PCN – Process Change Notification

Change:	GSA.8821.B.301111
Date:	2017/05/11
Author	Haley Tsai

Model#	Part Number	Changes
I-Bar Penta-band Cellular Antenna 3m RG174 SMA(M)	GSA.8821.B.301111	<ol style="list-style-type: none"> 1. Amend Package Rule. 2. Amend tolerance of heat shrink tube. 3. Amend double sided adhesive model 4. Amend label material.

Illustration of Change

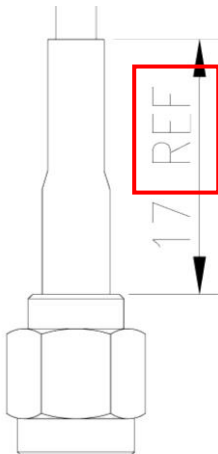
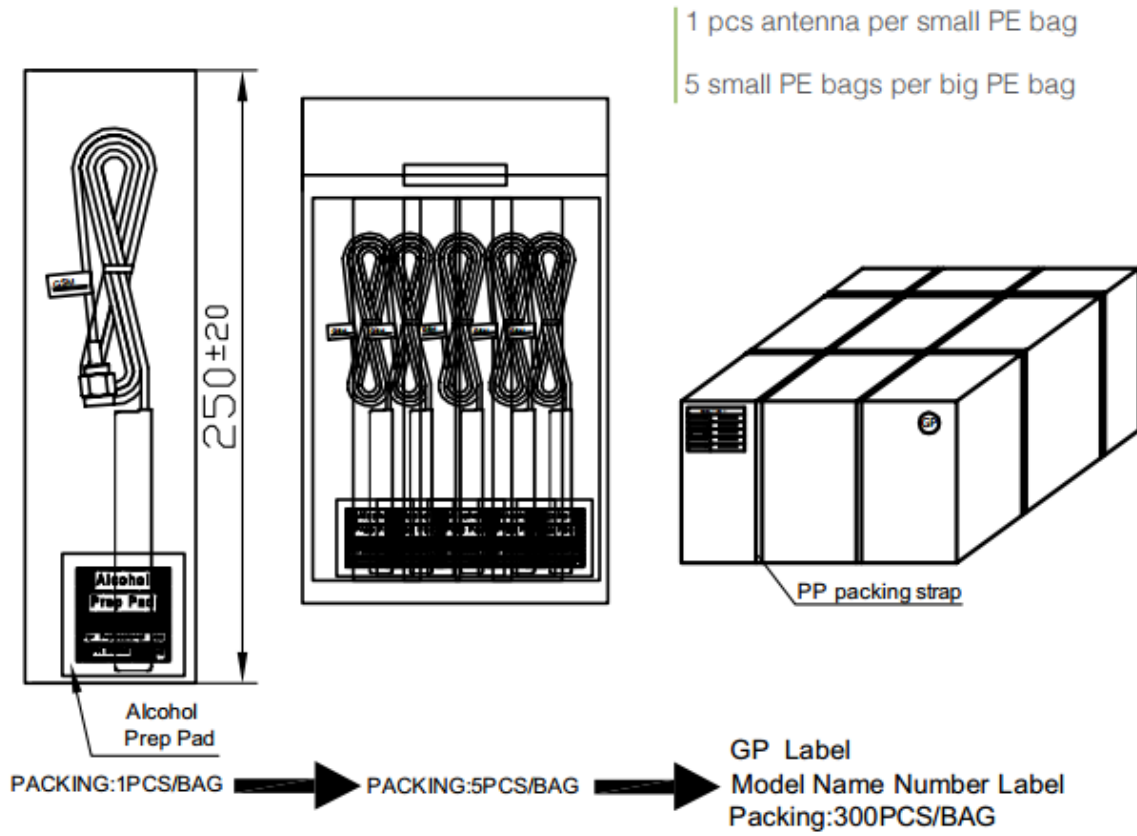
Old drawing

Double Sided Adhesive	001011J000020A	3M 1600T	White Liner	1
GSM Label	001011J000007A	Coated Paper	Blue	1

New drawing

Double Sided Adhesive (Gray Foam)	001011J000020A	3M 1600TG	White Liner	1
GSM Label	001013K010051A	PEPA	Blue	1
